Caballeros De Oro Estates

CITY OF LAS VEGAS			DATE:	
INTER-OFFICE MEMORANDUM			November 14, 2016	
TO: Land Development Services Department of Building & Safety			FROM: Albert Sung, P.E.  Flood Control Project Engineer Department of Public Works	
SUBJECT: Drainage Study for: Caballos De Oro Estates			COPIES TO: Balova Engineering	
Cross Streets:	NWC of Cliff Shadows Pkwy & Buckskin Ave.		Caballos De Oro Estates, LLC	
File Number:	F:\Depot\DSMemos\DS4811C.doc		Bart Anderson, P.E., DevCo	
Parcel Number:	137-12-301-009		CCRFCD	
Zoning Action:	SDR-XXXXX etc.		CCPW	
FEMA Flood Zone	YES	NO	X	
Proposed Storm Drain	YES	NO	X

TECHNICAL DRAINAGE STUDY

SUBJECT: TECHNICAL DRAINAGE STUDY FOR CABALLOS DE ORO ESTATES
CLV DS 4811A / RFCD16-9732
Supplement

EAST PROPERTY LINE
NOT TO SCALE

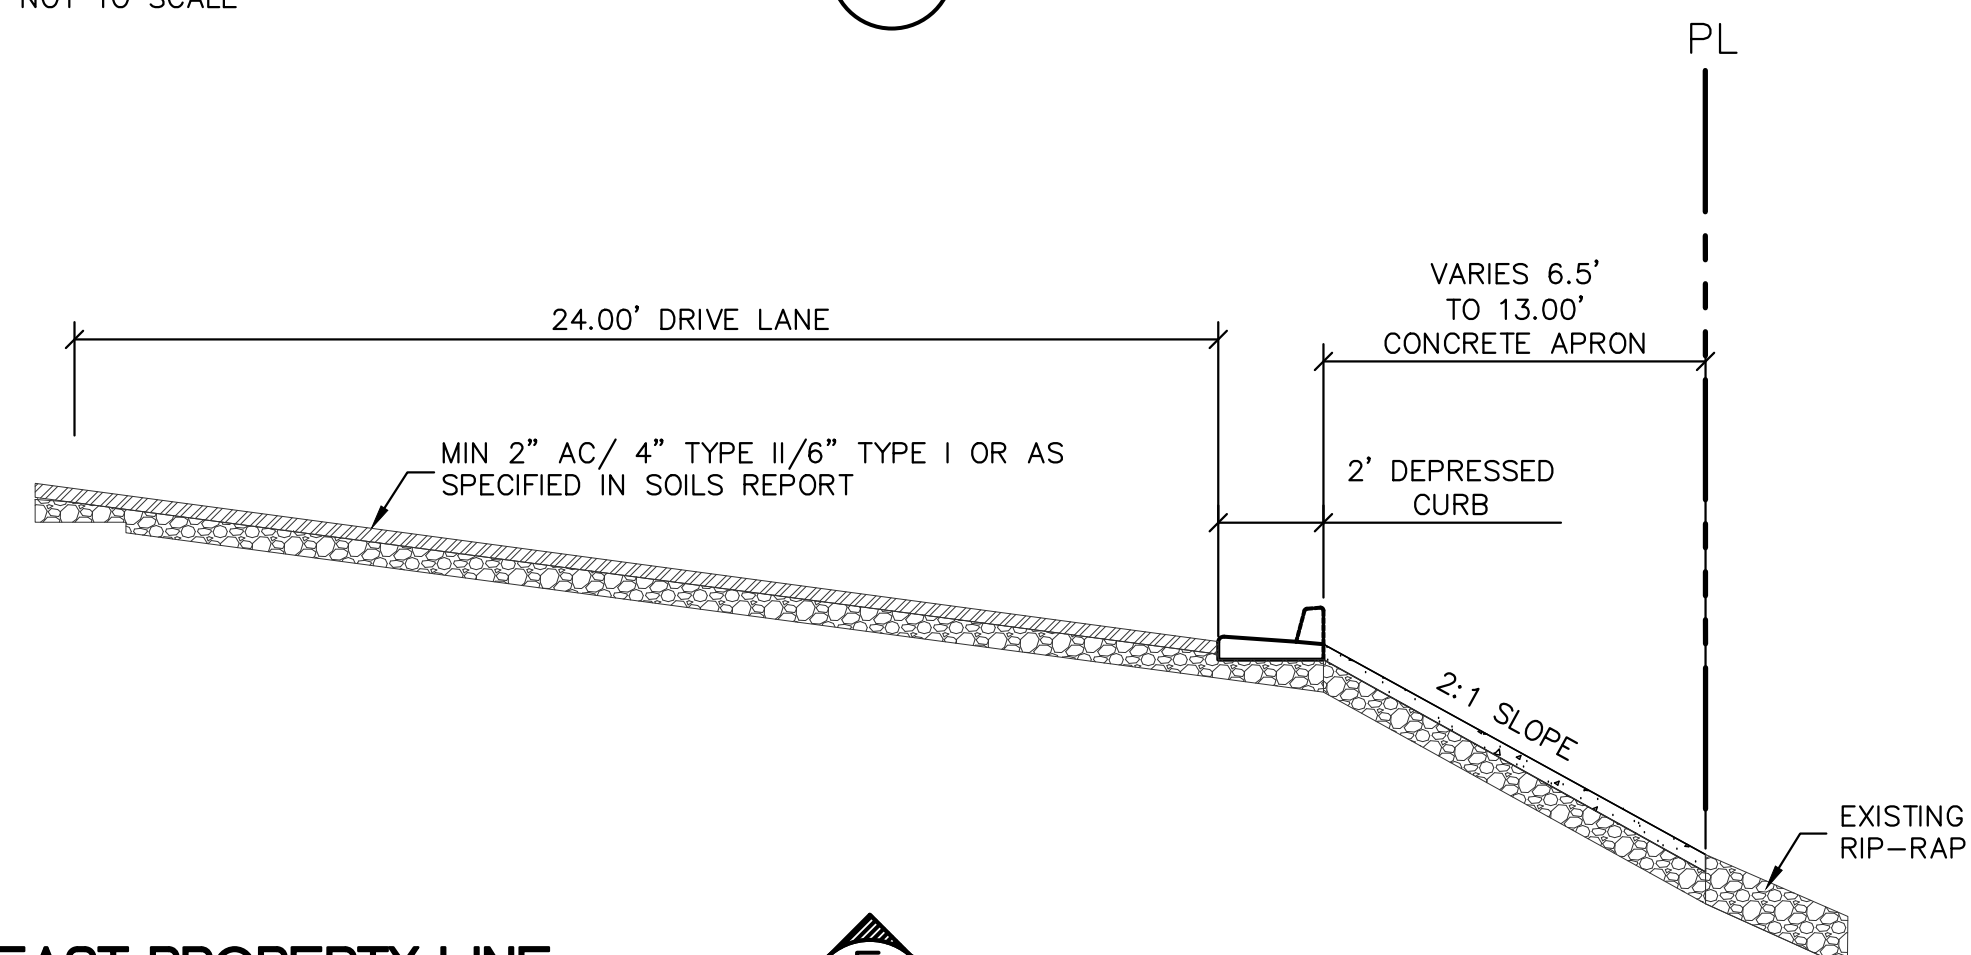
The District would like to see an additional detail cross section where it ties into GOL40026 and provide 3-ft cutoff walls along this section.

Additionally, delineate drainage easement on C/C4 and correct typo on I/C5. If you can provide supplement plans to us and the City, we will be able to provide District concurrence.

- A cutoff wall was added and a cross section was shown sheet C4.
- The drainage easement was delineated on sheet C4.
- Type was corrected on C5
